**CITY OF CLEARWATER
PLANNING & ZONING**

TO: Clearwater Planning and Zoning Committee

RE: Conditional Use Permit and Site Plan to construct an industrial allow construction of an industrial building for major vehicle repair, office, warehouse and accessory open storage south of Heaton Boulevard and Shorty Street (PID#s 104500022202 and 104500022207)

We have reviewed the preliminary site plan created by Plowe Engineering, Inc. titled “**Blaine Brothers**”, City of Clearwater, Minnesota dated January 21, 2019.

COLORED ELEVATIONS

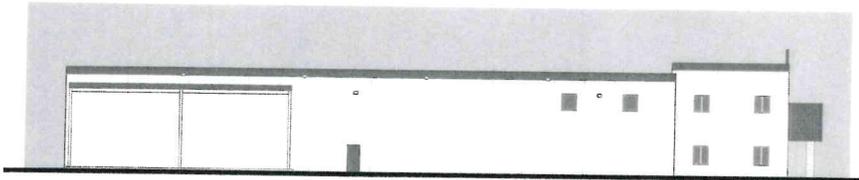
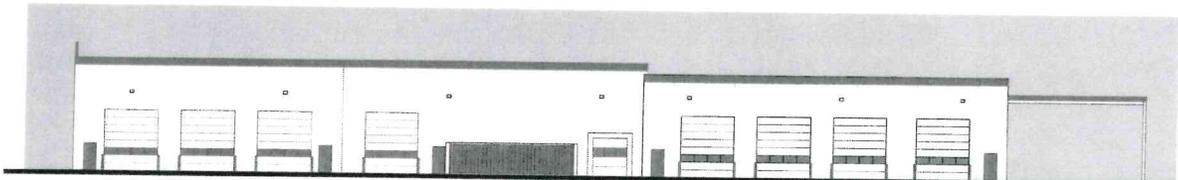
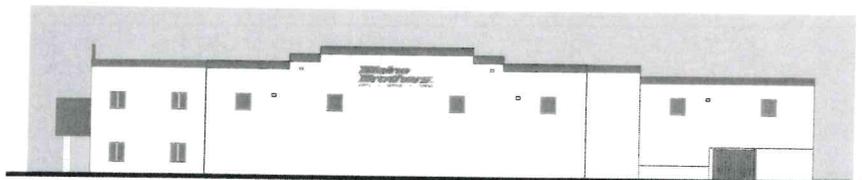
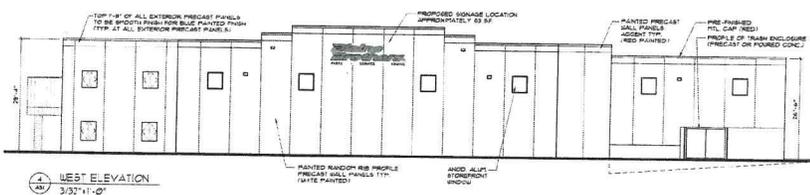
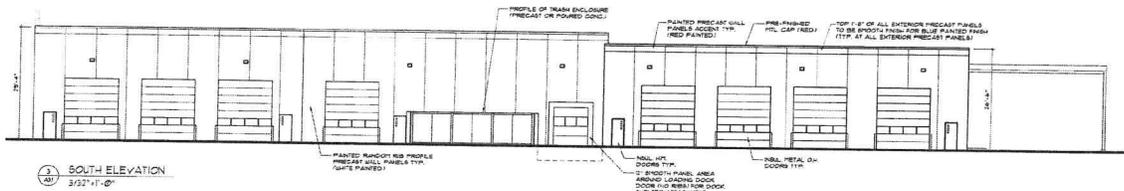
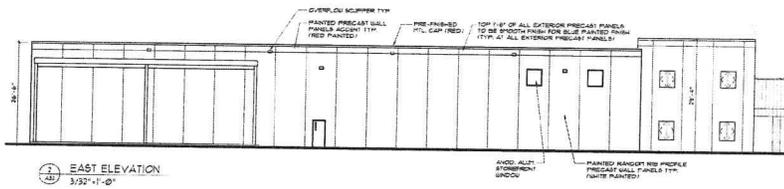
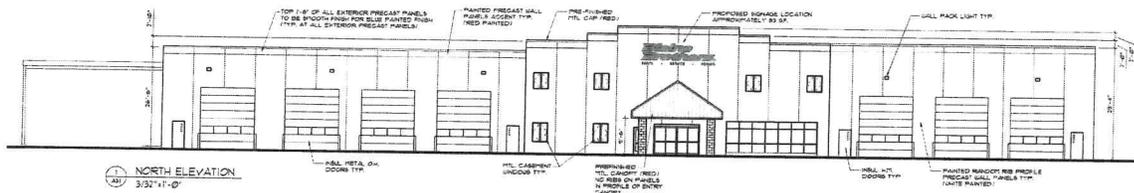
Section 117-128 (Performance Standards for Conditional Use Permits) states that “The architectural appearance and functional design of the building and site shall not be so dissimilar to the existing or potential buildings and area so as to cause impairment of property values or a blighting influence. All sides of the principal and accessory structures are to have essentially the same or coordinated, harmonious exterior finish materials and treatment.” The applicant has submitted rendered building elevations demonstrating that the proposed building will be white with red trim.

The applicant has proposed a trash enclosure on the south side of the building. Consistent with the performance standards of Section 117-1106 of the Zoning Ordinance, the color elevations show that the trash enclosure is covered, is fully enclosed, and will be constructed using precast or poured

SITE PLAN

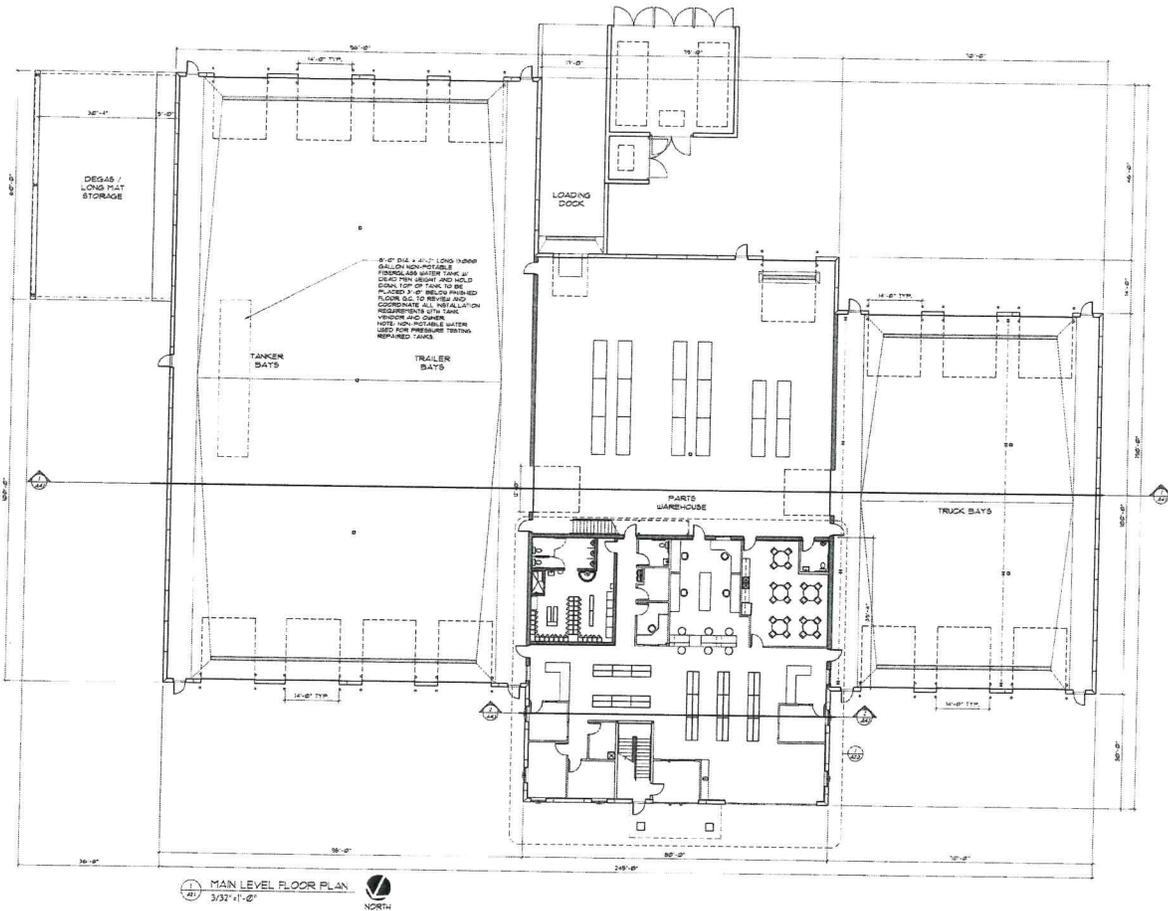
Section 117-1037 of the City Code requires that open storage be screened using a fence or green belt planting strip to provide a visual buffer. The planting strip shall be designed to provide complete visual screening to a minimum height of six feet. The green belt planting strip may contain evergreen and/or deciduous trees. The applicant has proposed trees approximately 30 feet apart along the perimeter of the site adjacent to the spaces for open storage. Staff finds the proposed plantings do not provide a complete visual screen at the current spacing. The plans will need to be revised to show 15 foot spacing between trees on the lot lines adjacent to the open storage spaces.

Section 117-1131 of the Zoning Ordinance requires that the applicant submit a tree preservation plan. The plan sets shows that a stand of trees on the southwest corner of the site will remain undisturbed. The lot does not appear to have any other trees. Staff has included a condition that the applicant submit a final tree preservation plan prior to the release of a grading permit.

The applicant's plans show some screening of the open storage. Staff has included a condition to increase the number of trees screening the open storage area.

The open storage is proposed to be screened using a green belt planting strip. Staff has included a condition to increase the number of trees screening the open storage area.

1. Revise landscape plans to incorporate additional plantings to screen the open storage spaces from adjacent properties.
2. Revise the lighting plan to show compliance with the maximum ½ foot candle requirement.
3. The applicant must obtain all necessary permits from MNDOT and Wright County.
4. The applicant shall submit a final tree preservation plan.
